# 1. COA-055420-2019

2816 East Franklin Street

## STAFF REPORT

**Demolish a one-story masonry garage and construct a new, two-story accessory building.**

Figure 1. Sanborn Map, 1905

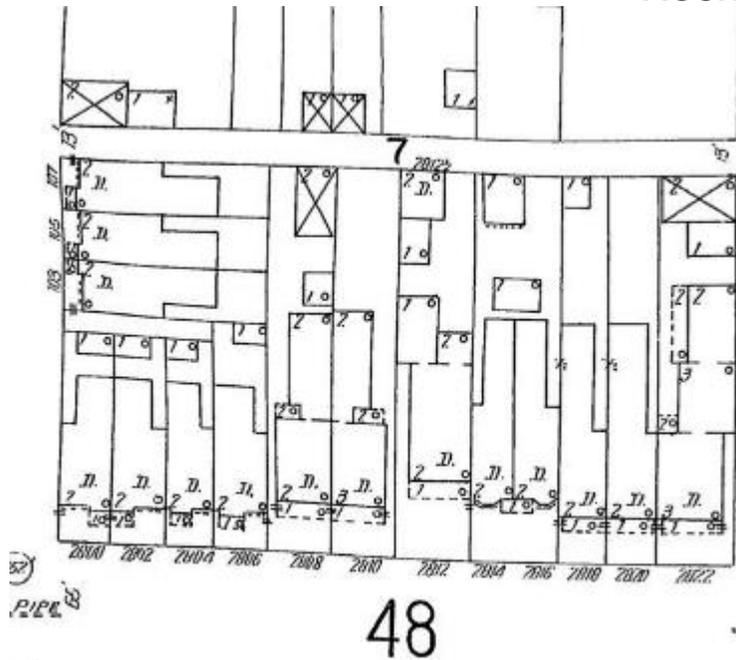
The mass of the proposed secondary building is smaller than the primary resource, and located at the rear. Sanborn maps indicate historically a one-story outbuilding has been present on the site since at least 1905. The Sanborn maps also indicate that, historically, two-story outbuildings have been located on the subject alley, though none are still standing.
